SUBJECT: Forwards open items from Structural Engineering Branch
 811005-08 meeting in Woodbury, NY.

Subject: NUCLEAR PROJECT NO. 2
OPEN ITEMS FROM SEB MEETING

Attached are sixty copies of the open items from the Structural Engineering Branch meeting held in Woodbury, New York, October 5 - 8, 1981.

WNP-2
NRC-SEB MEETING

Figure 130.055-2

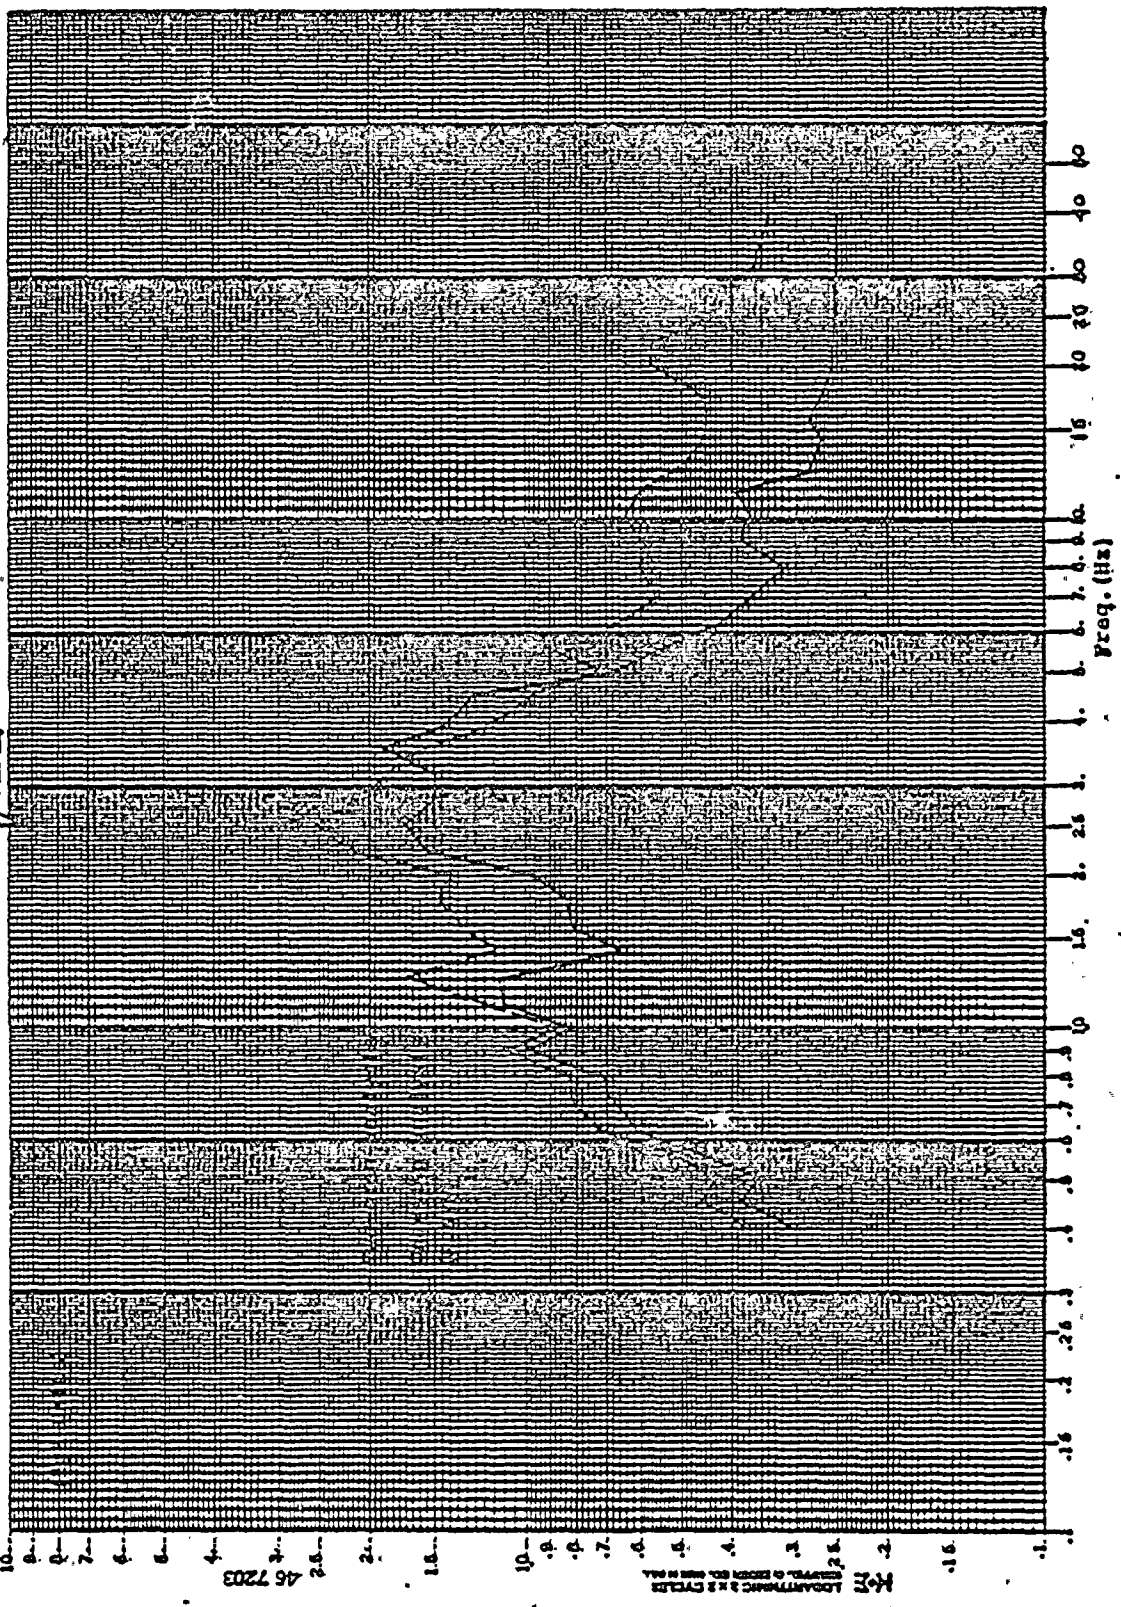
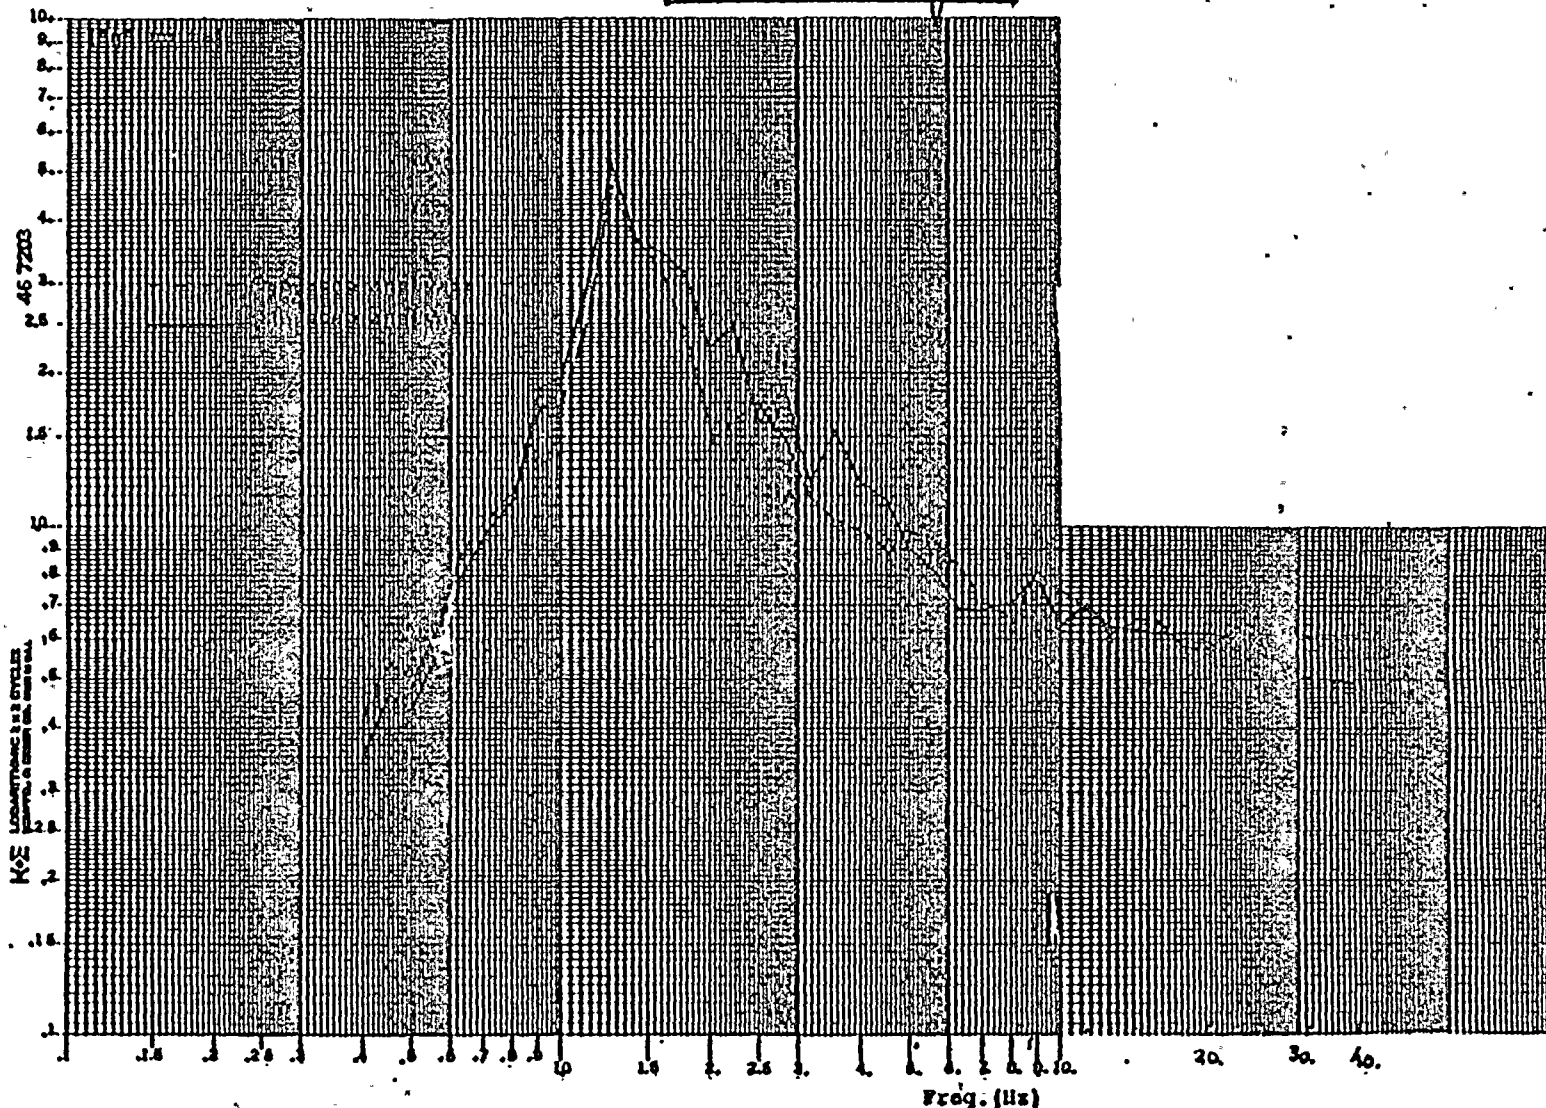
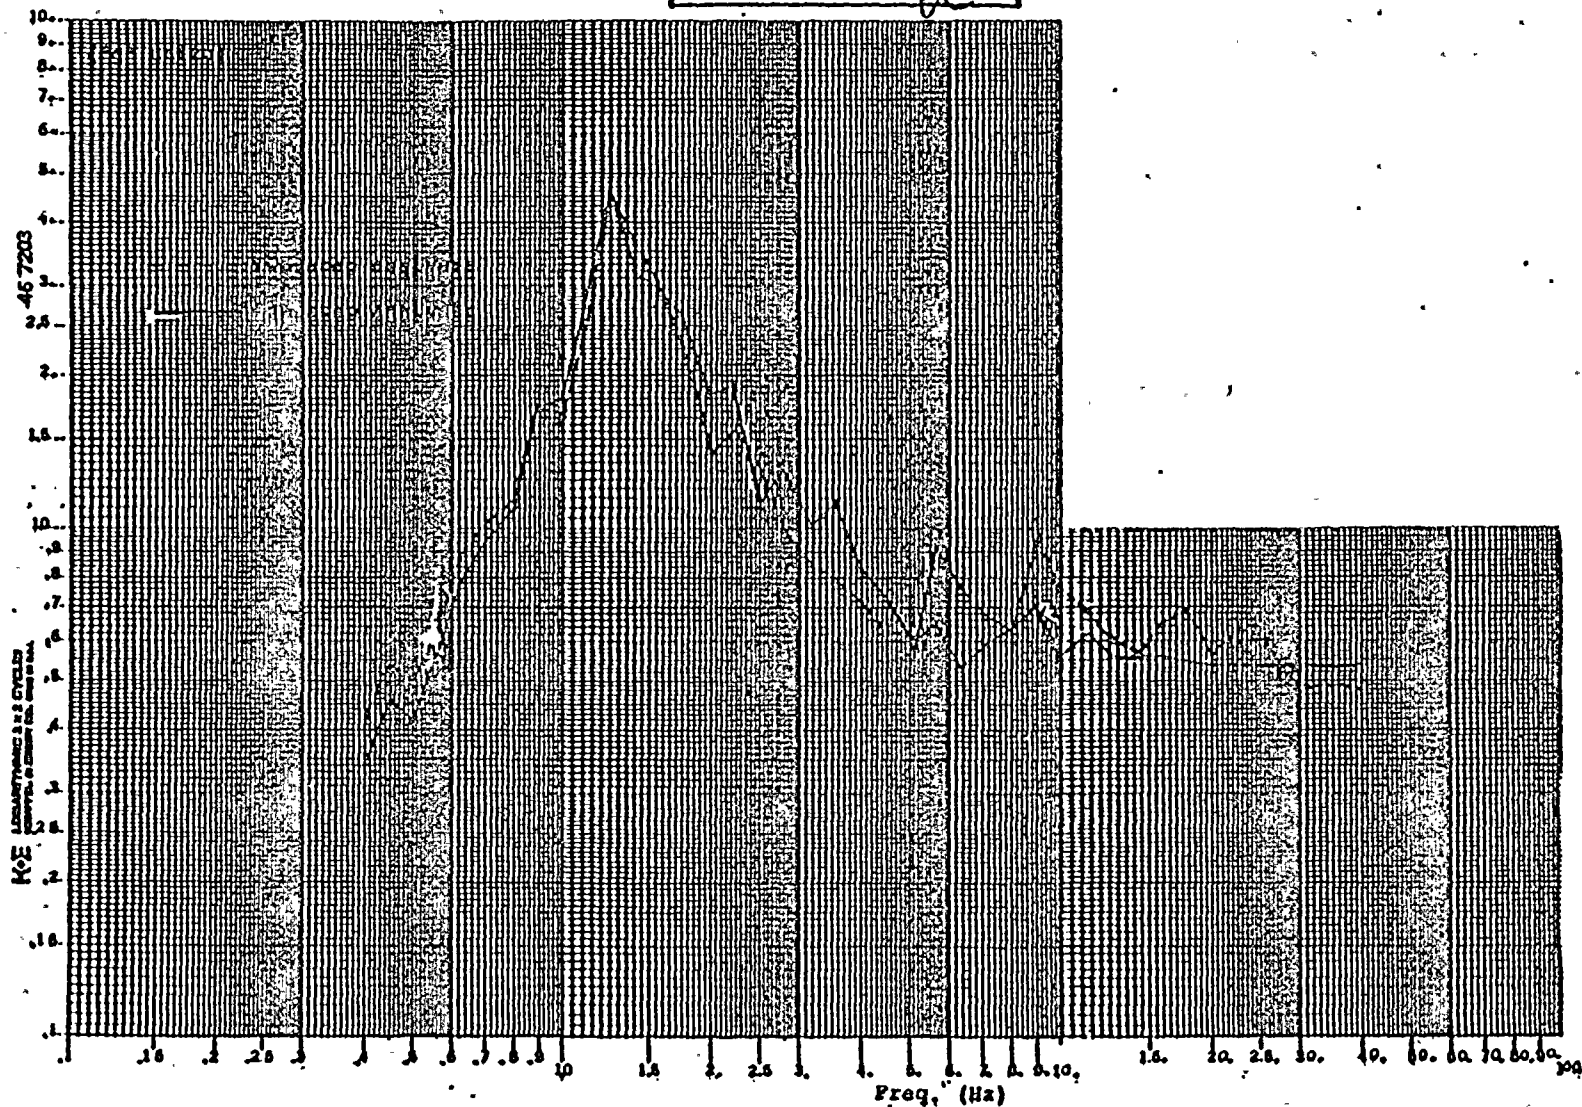
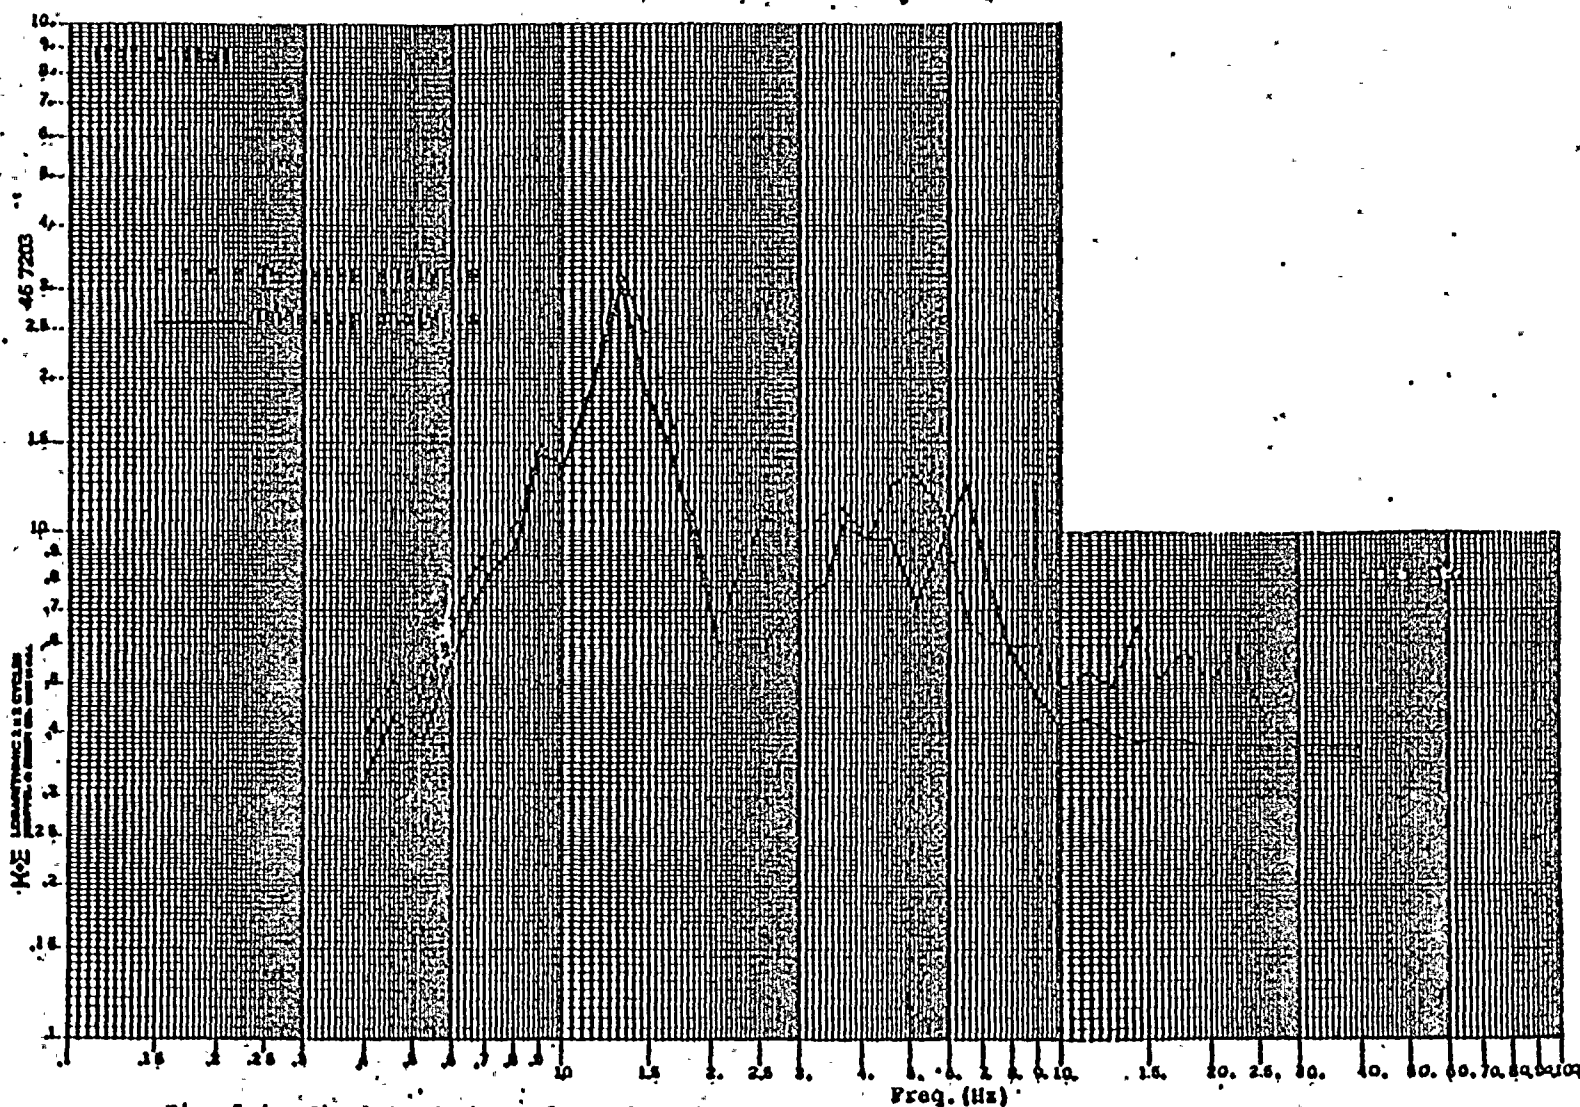
To support this conclusion, acceleration floor response spectra are provided on Figures 130.055-1 through 130.055-4 for representative locations in the reactor building using both methods of analysis. The curves labelled "two-step analysis" (dashed lines) represent the building response obtained from a two step substructure approach using compliance functions to represent the equivalent soil stiffness. The curves labelled "one-step analysis" (solid lines) represent the building response obtained from a (one-pass) finite element dynamic analysis of the coupled soil/structure.
